MEMORANDUM

DATE: June 6, 2023 **PROJECT NO.** 350.00737.000

SUBJECT: Expressway – Grant Creek Floodplain Analysis, Supplemental Response to DNRC Questions

Figure 1. Typical compound channel cross section (taken from Petikas Et al., 2020).

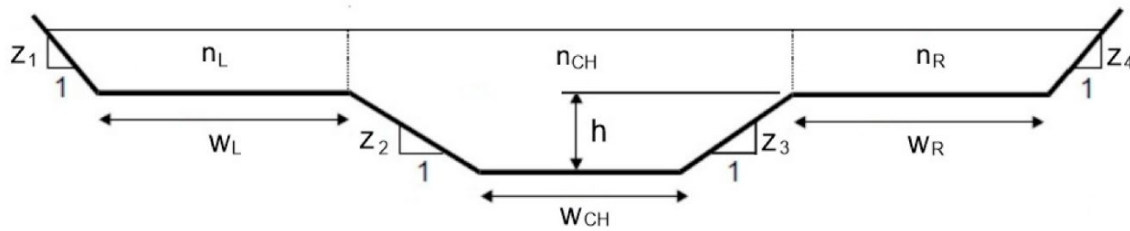
1. *Why has the HEC-RAS hydraulic model produced numerous messages about multiple critical depths at cross section 62 through cross section 248? Since the cross section are not complex in nature, can you please discuss/identify why the critical depth messages are appearing in the model (i.e., is it due to channel steepness, pressurized bridge flows, a combination, or other factors.).*
2. *There is a blocked obstruction at cross station 157. Can you identify what this is and why it is contained in the model?*

The Grant Creek HEC-RAS hydraulic model identified multiple critical depths at many of the model cross sections in the reach between River Station 62 and 248. These notifications were listed as notes (not as warnings or errors), which are simply providing information about how the model is performing computations. Critical depth is the flow depth, for a given discharge and cross section, where the specific energy is at a minimum. In simple trapezoidal or rectangular channels, there is only one critical depth for a specific discharge (Petikas, Et al, 2020). Open channels with floodplains or flat overbank areas, are described as compound channels (**Figure 1**) and may have more than one critical depth per discharge (Petikas, Et al, 2020; HEC, 2020).
